2007 - 2013 Corvette: GM TechLink: Low Oil Pressure on V8 Engines

Subject: Low Oil Pressure on V8 Engines

Source: GM TechLink

Date: August 10, 2015

Fig. 3

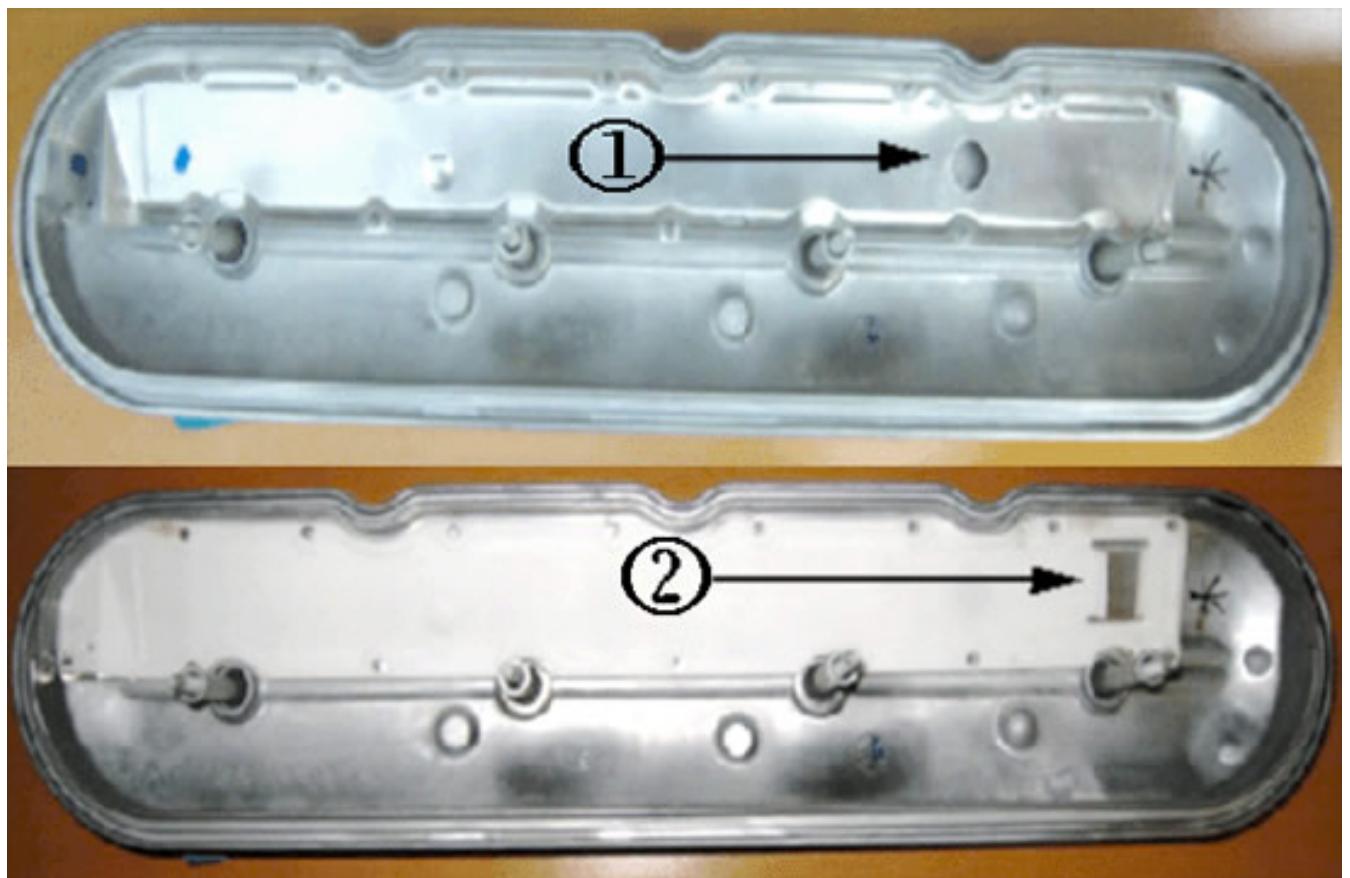
If the engine has been properly repaired and cleaned, inspect the left rocker cover (square baffle) (Fig. 3, #1 – old design; #2 – new design with square baffle) and verify that the baffles can hold water and do not leak. If any leaks

are found, clean and seal the edge of the baffle with RTV, if possible, or replace the valve cover. Thoroughly clean and dry the valve cover before installation and/or resealing.

In addition, change the engine oil and replace the oil filter with a PF48E filter.
